AGENDA

President and Board of Trustees
Village of Arlington Heights
Board Room

November 6, 2017

PC Project Number: PC 16-012
Project Title: Ivy Hotel
Address: 519 W. Algonquin Rd.
PIN: 08-16-103-008, 08-16-103-009

Site Plan

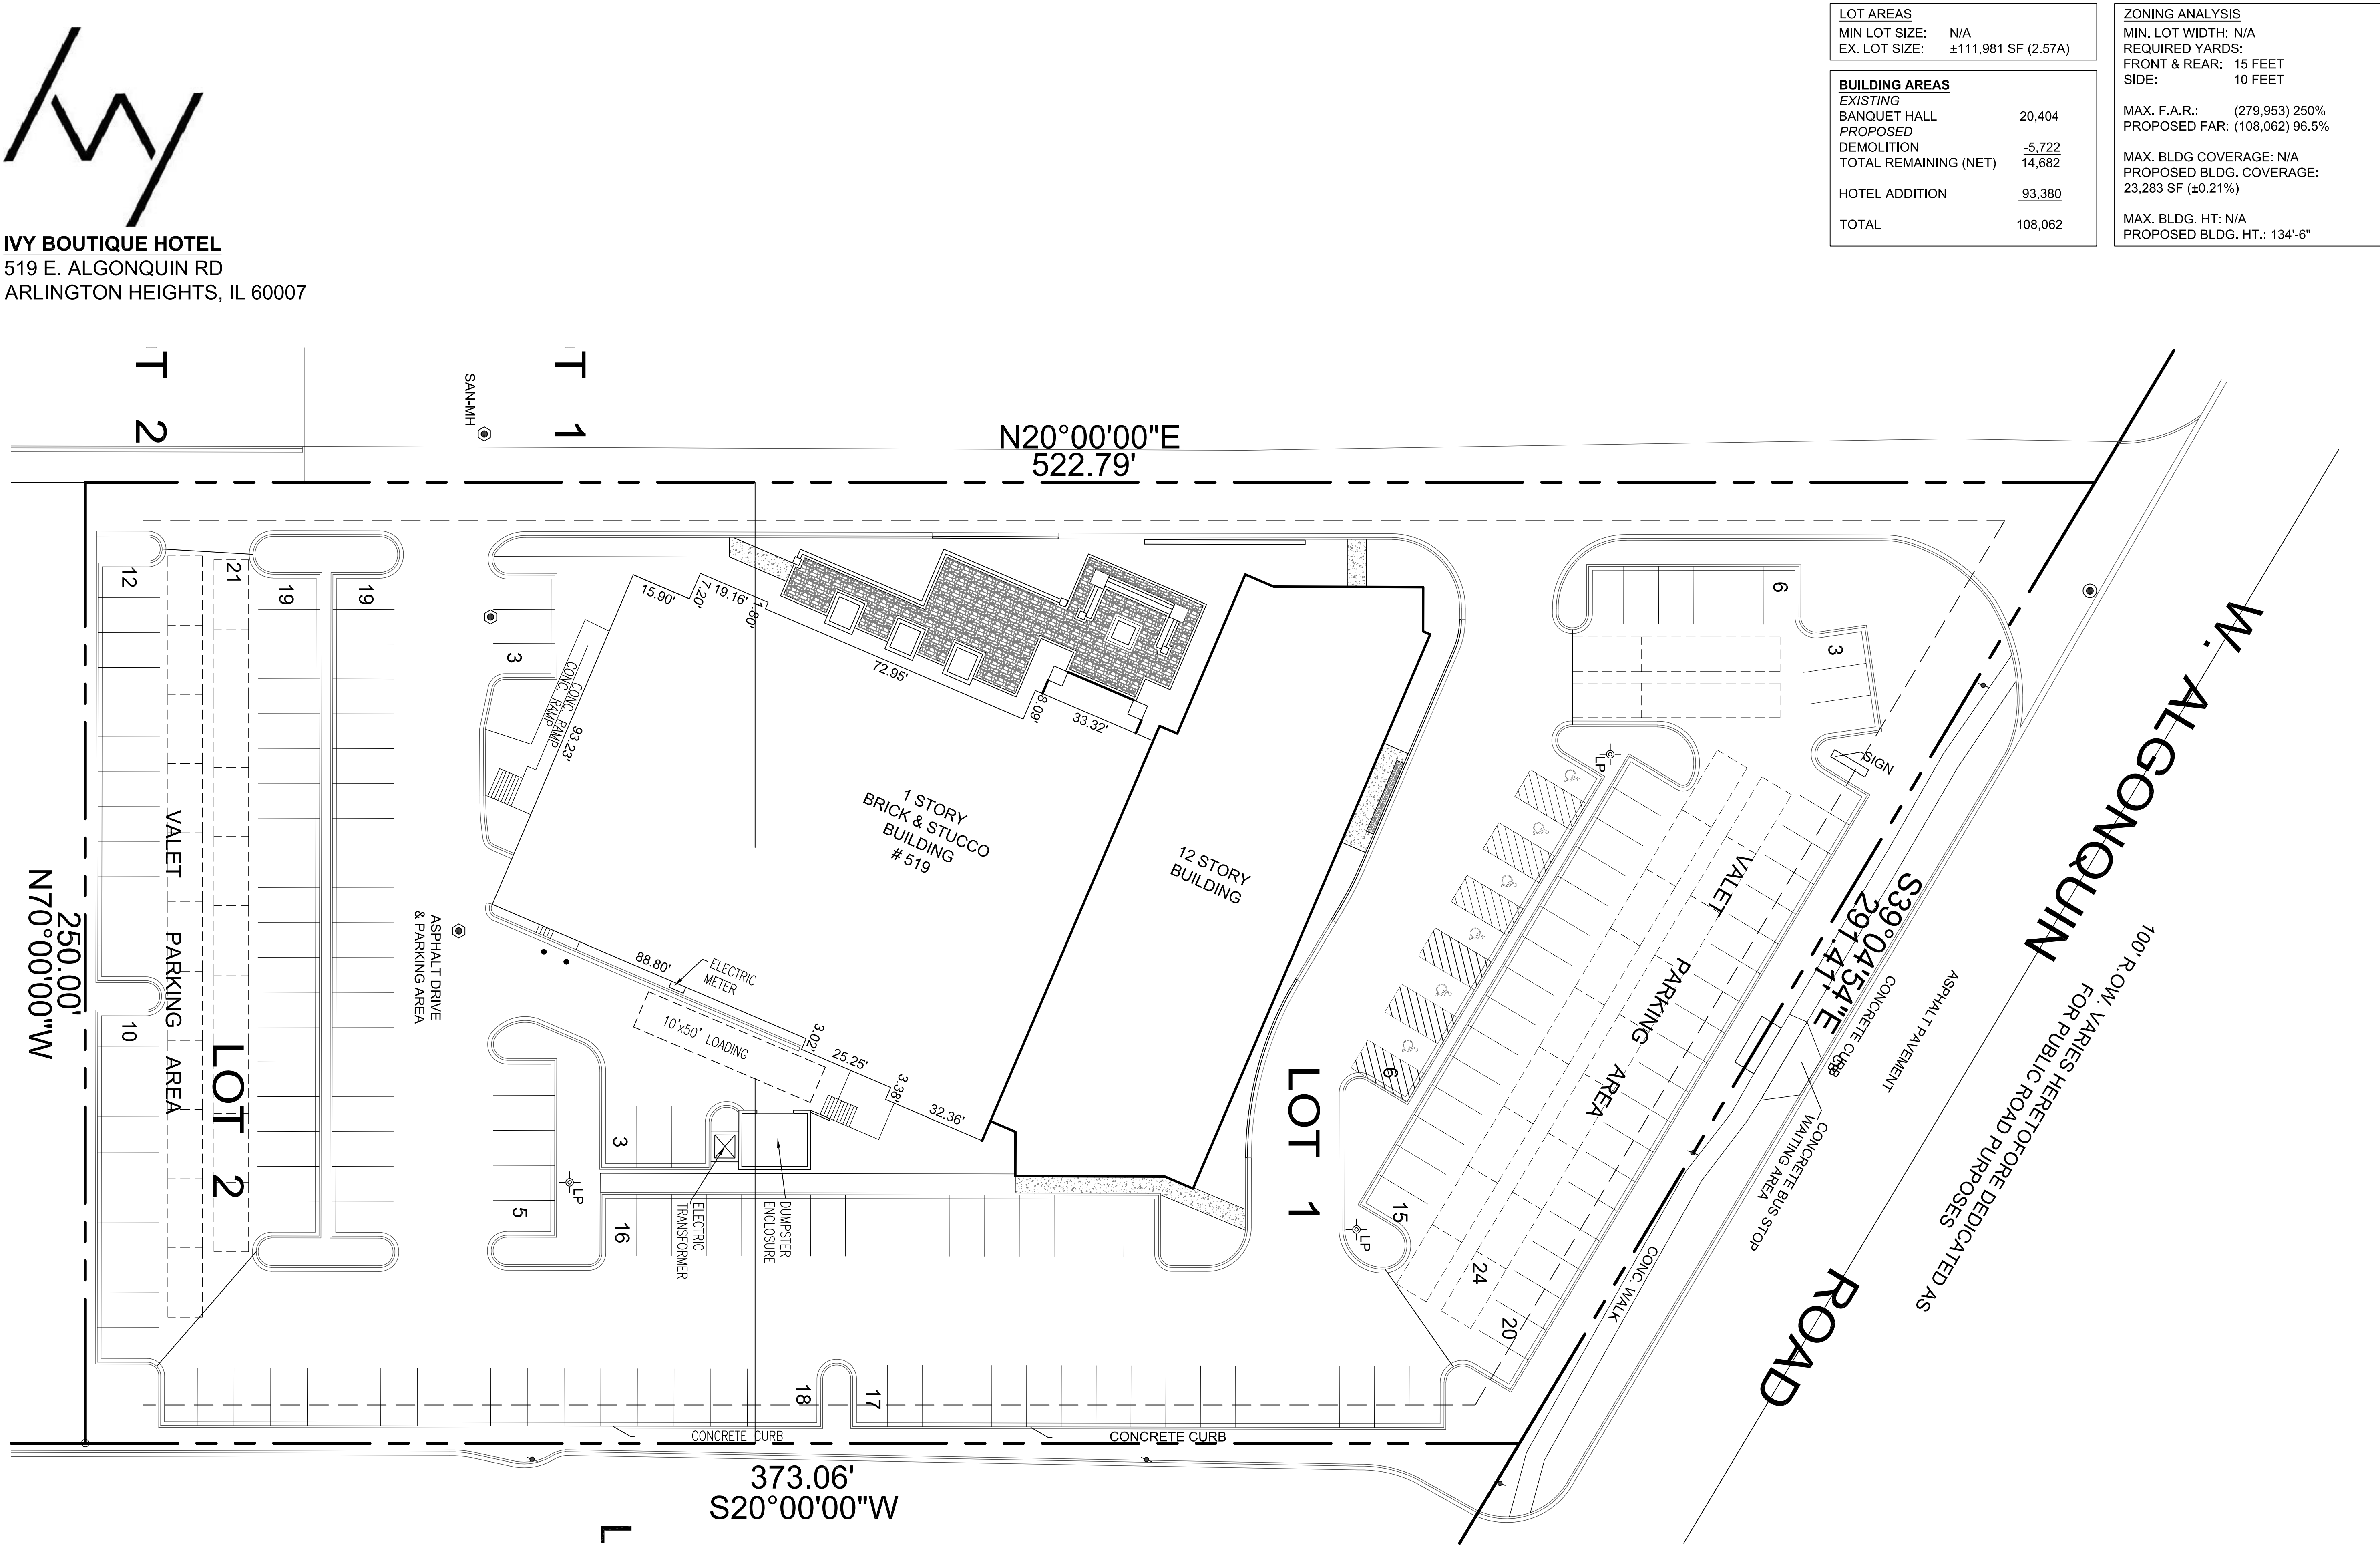
8. Many of the plan sheets are still inconsistent. Specifically:
 - a. The Site Plan (sheet A-0) does not show the new curb and sod area along the western side of the building.

25. The Site Plan (sheet A-0) indicates that there are a total of 150 parking spaces proposed on the site as a result of the Ivy Hotel development. However, 152 spaces are shown on the plan. Additionally, the Site Plan indicates that 25 valet spaces will be provided, however, 27 valet spaces are shown on the plan. Please revise the plan to reflect the actual number of proposed parking spaces and valet spaces. Additionally, please consider that the Ordinance #00-012, which granted the Special Use Permit for the banquet facility, limits valet parking to only the "plan east and west" circulation aisles.
